OPERATOR'S MANUAL
RADIO SETS AN/VRC-24
AND AN/TRC-68

TM 11-5820-222-10 }
TO 31R2-2TRC68-1 }
CHANGES No. 4 }

TM 11-5820-222-10 }
TO 31R2-2TRC68-1 }
CHANGES No. 6 }

No. 9

Figure 8.1 Case, Standard Components CY-4868/TRC-68A.

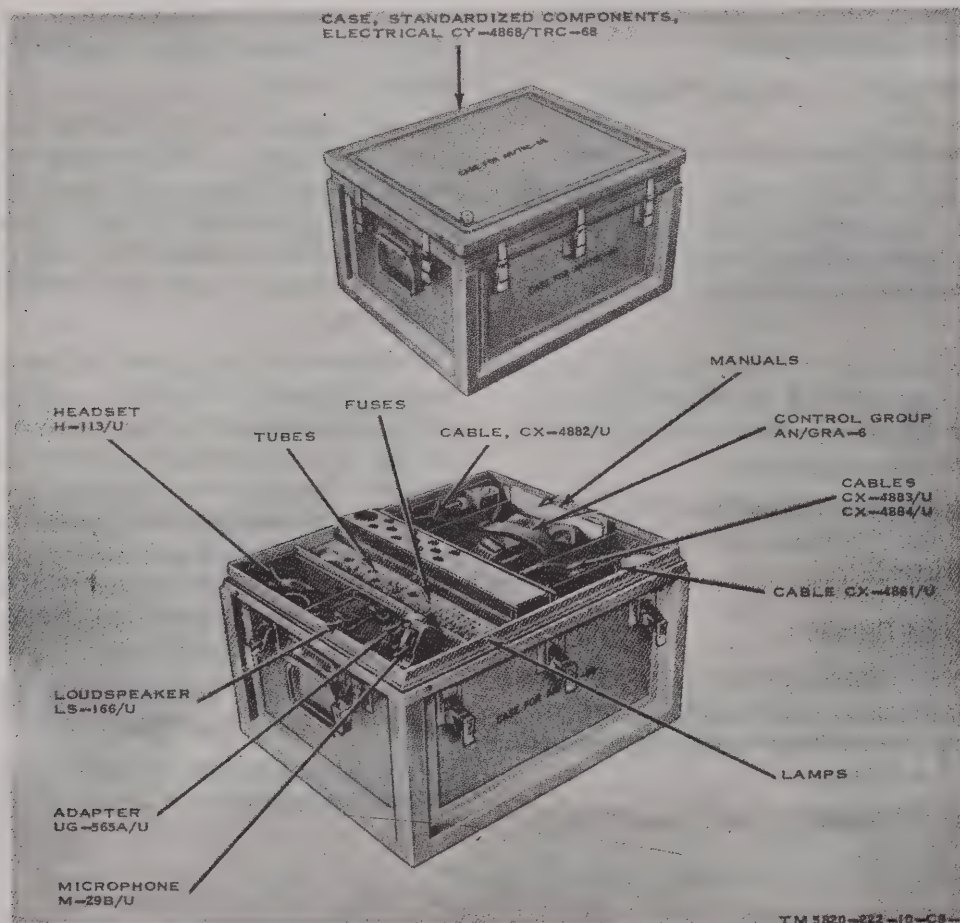
Page 11. Add figure 8.1 after figure 8:

Case, Standard Components CY-486-8/TRC-68A (fig. 8.1) contains separate stowage compartments for the following accessory equipment supplied with the AN/T-RC-68A:

Figure 10. Running spares.

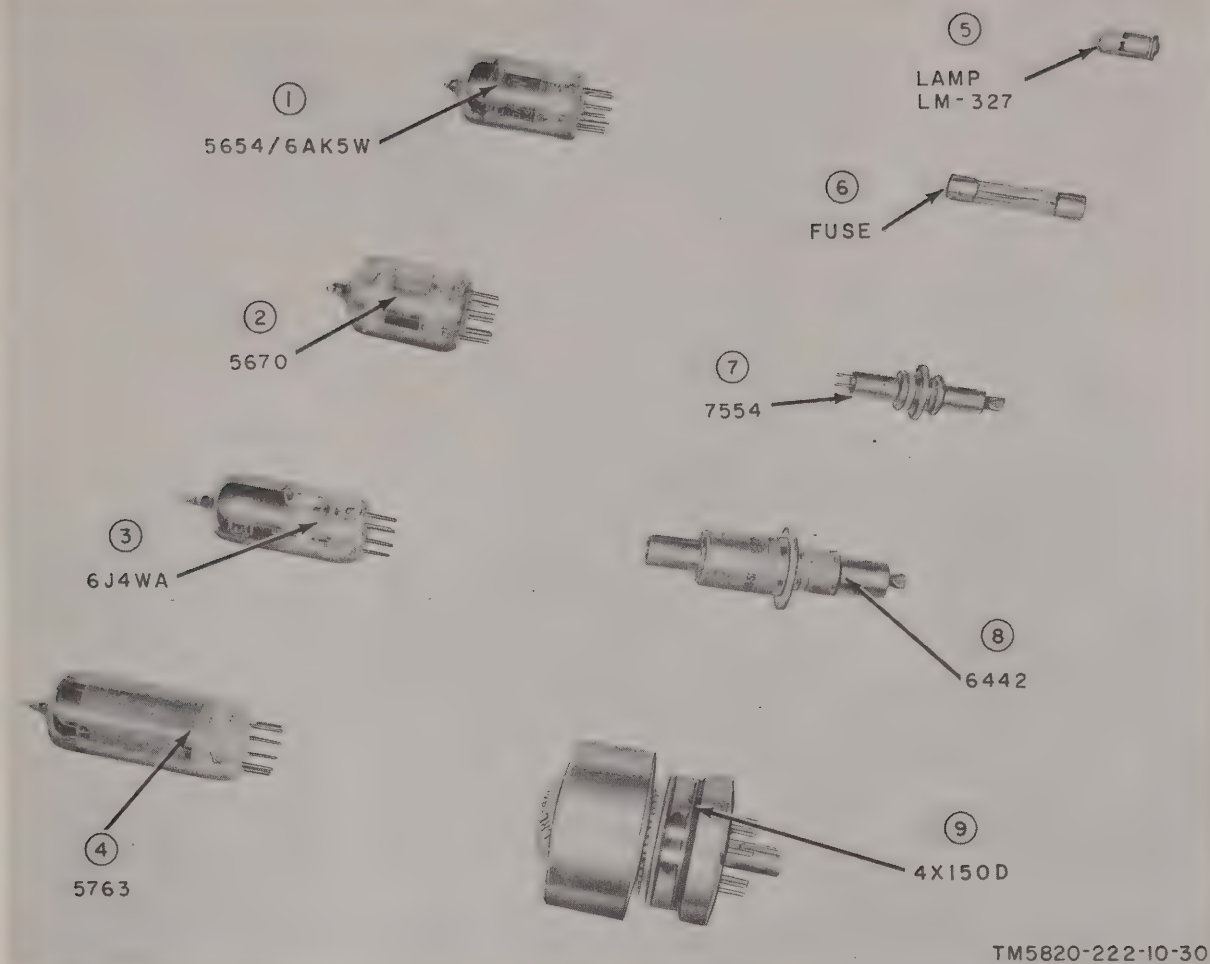
Page 13, figure 10. Add the following note to figure 10:

Note. On order No. 19275-PC-60, serial numbers 41 and above and on the A models, electron tube 7609 is included in place of the 4X150D.

Figure 14. Receiver-Transmitters RT-323/VRC-24 or RT-441/TRC-68, controls, indicators, and receptacles.

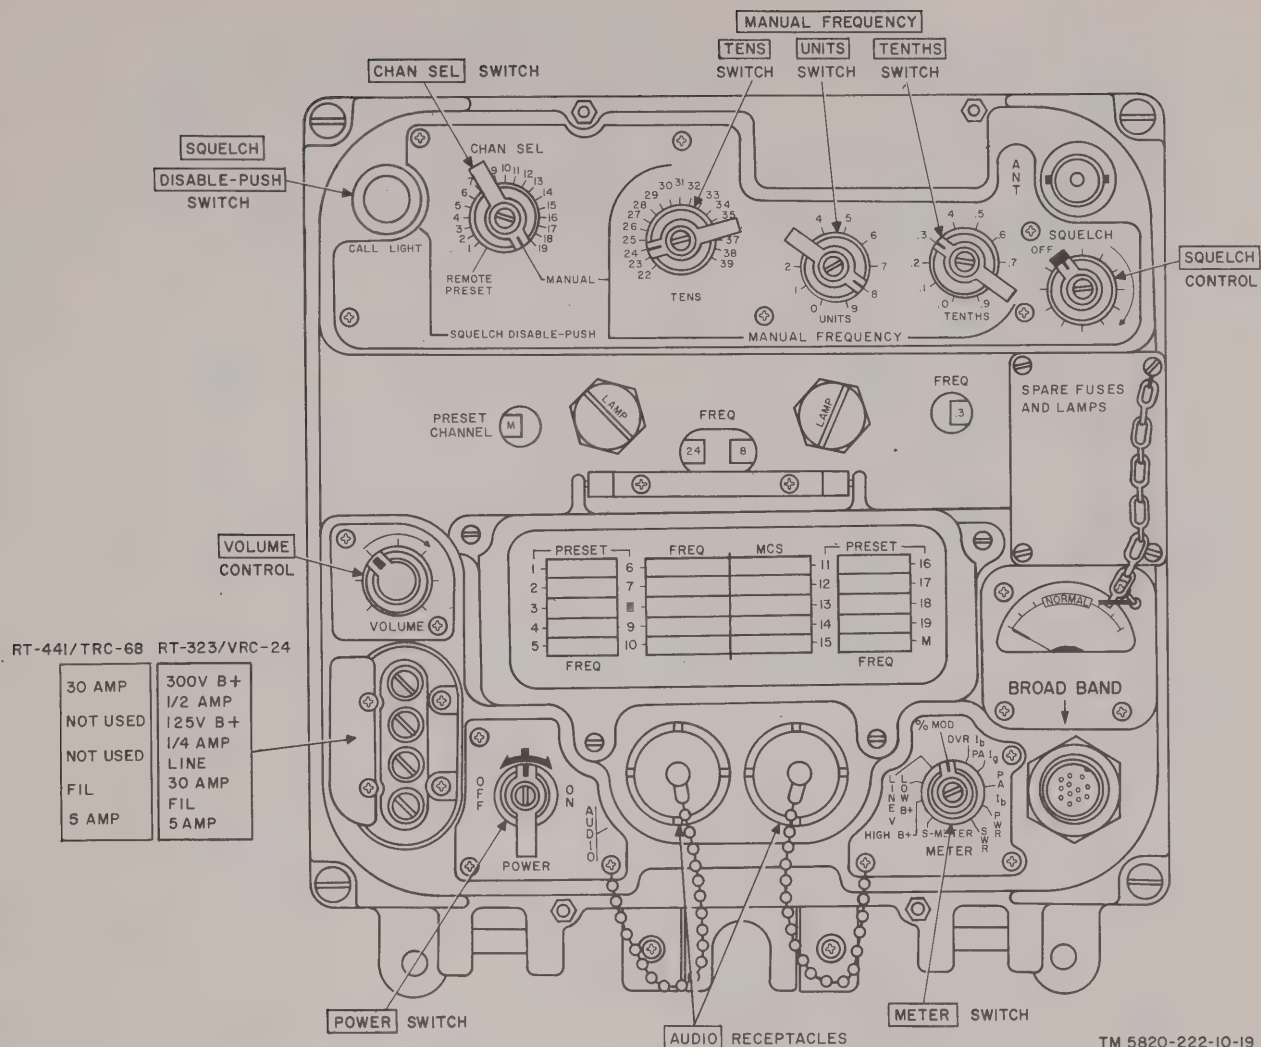
Page 91, figure 14. Add the following note to figure 14:

Note. The broad band receptacle is capped with a dummy connector on the A models.
